City of Lindsay Development Standard Addendum May 2006

Development Standard No. ST-6, Barrier Type Curb and Gutter.

BARRIER TYPE CURB AND GUTTER

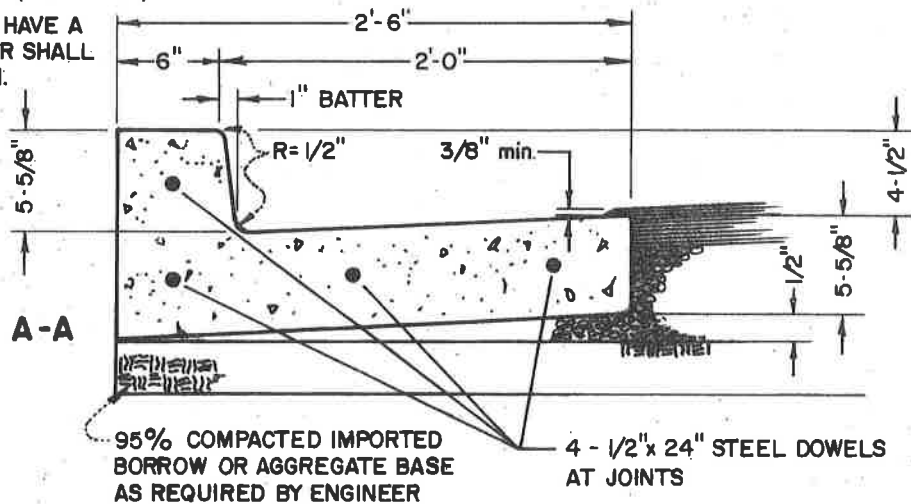
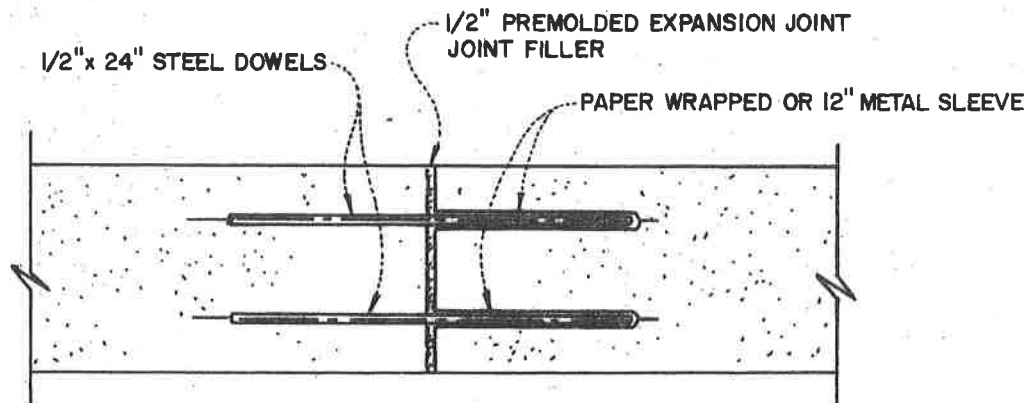
The following items shall be considered City of Lindsay acceptable construction practice and allowed for the construction of curb and gutter.

This applies to machine pour curb and gutter only. Allowances can be made for form and stake curb and gutter, but will be reviewed on a project by project basis.

- Steel dowels are required at cold joints only. ½" diameter x 24" long embedded 12" into each section of curb and gutter. A total of 4 dowels (2 in curbing, 2 in gutter pan) are required. Expansion felt shall be required at cold joints also.
- Weakened plane joints (deep joints) shall be required at 20' o.c.; the definition of weakened plane joints shall be 1" minimum depth and shall be finished with a scoring tool leaving the edges rounded.
- "Beauty Mark" joints (surface joints) shall be required at 10' o.c.
- Expansion felt may be omitted from each driveway location as directed by the City representative.
- "0" (zero) lip is required at all handicap curb depressions.
- ½" lip, maximum, is required at all driveway depressions.
